MONTGOMERY COUNTY PLANNING DEPARTMENT
THE MARYLAND-NATIONAL CAPITAL PARK AND PLANNING COMMISSION

MEMORANDUM

REVIEW TYPE: Preliminary Plan of Subdivision (*Resubdivision*)

PROJECT NAME: Locust Hill Estates
CASE #: 120080110
REVIEW BASIS: Chapter 50, Montgomery County Subdivision Regulations

Figure 2: Preliminary Plan

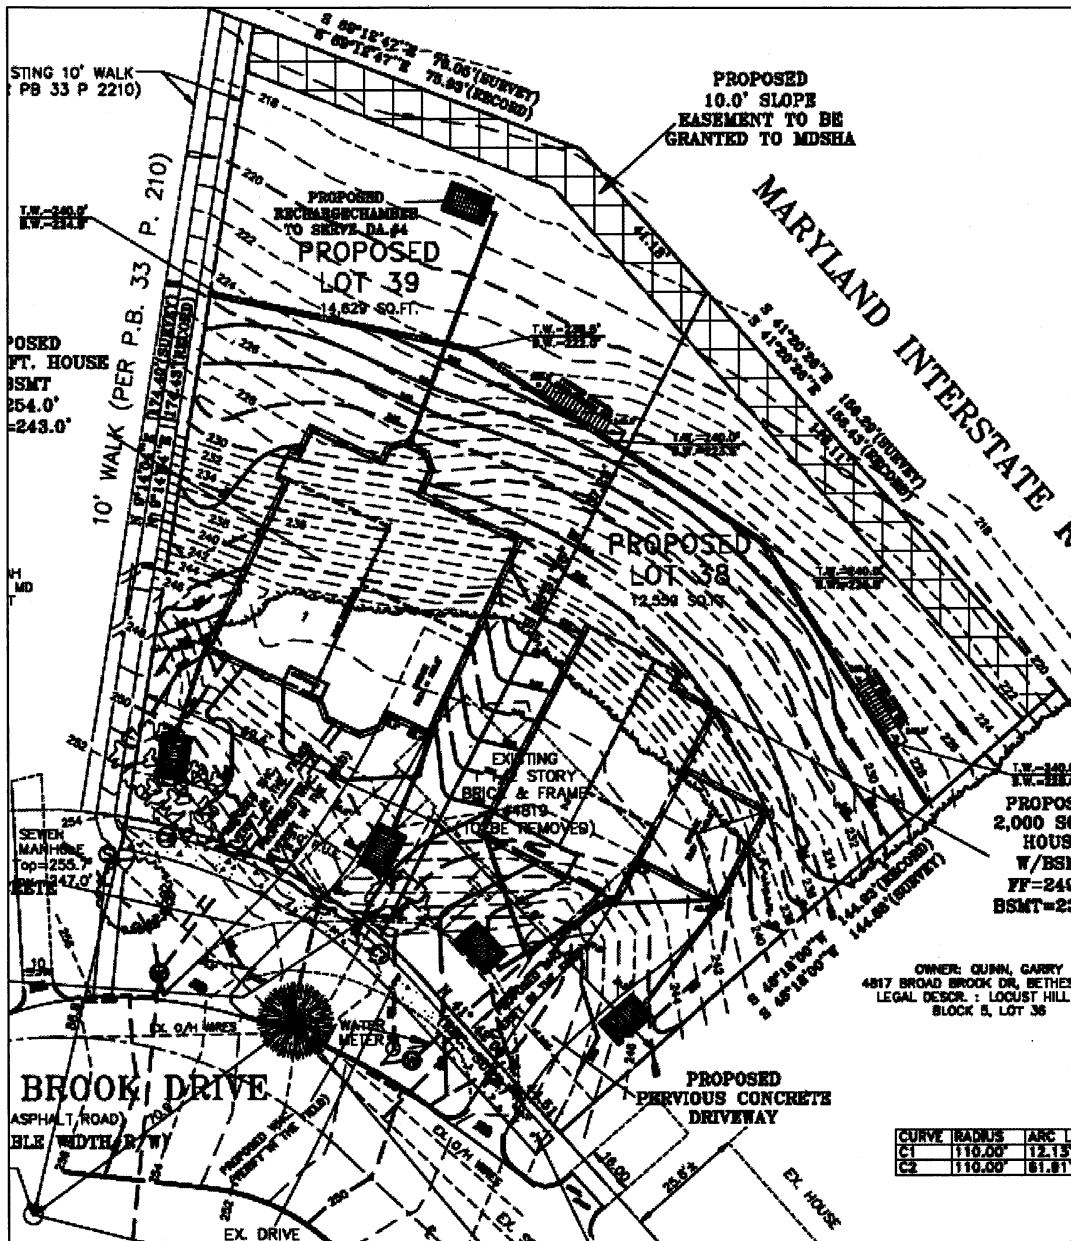
1. Show/label all existing planimetric and topographic details specifically driveways adjacent and opposite the site on the preliminary plan.
2. Necessary right of way dedication for Broad Brook Drive.

3. Grant necessary slope and drainage easements. Slope easements are to be determined by study or set at the building restriction line.
4. The sight distances study has been accepted. A copy of the accepted Sight Distances Evaluation certification form is enclosed for your information and reference.

5. In accordance with Section 49-35(e) of the Montgomery County Code, sidewalks are required to serve the proposed subdivision. Sidewalks are to be provided along the site frontage according to associated DPWT standard street section unless the applicant is able to obtain a waiver from the appropriate government agency.

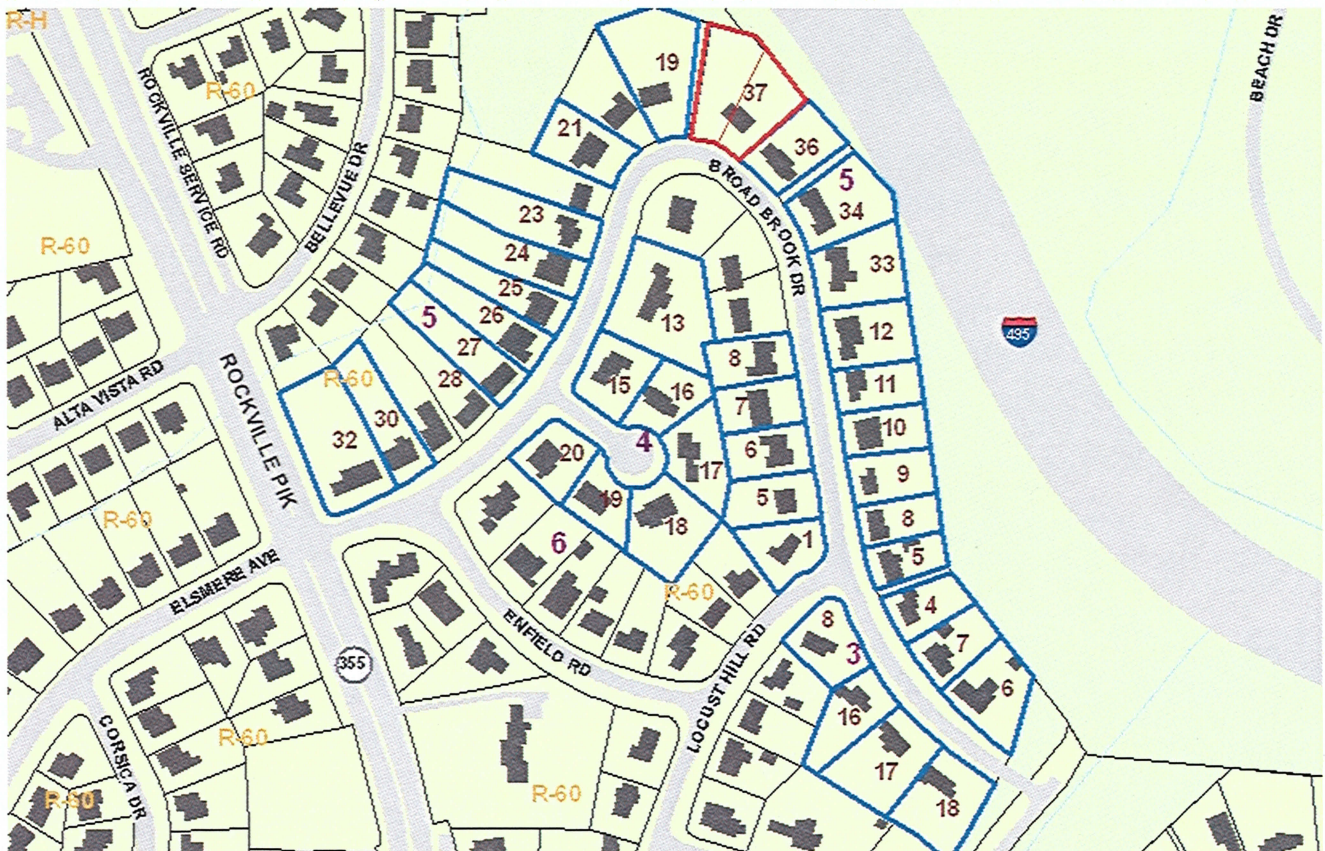
In administering Section 50-29(b)(2) of the Subdivision Regulations, the Planning Board must determine the appropriate "Neighborhood" for evaluating the application. In this instance, the Neighborhood agreed upon by Staff and the Applicant consists of 36 lots zoned R-60, highlighted in blue in the figure below. The Neighborhood includes lots within the same block as the Subject Property, confronting lots and lots with direct access to Broad Brook Drive that will be visually impacted by the proposed resubdivision. Parts of lots were not included. The designated neighborhood provides an adequate sample of the lot and development pattern of the area. A tabular summary of the area based on the resubdivision criteria is included in the data
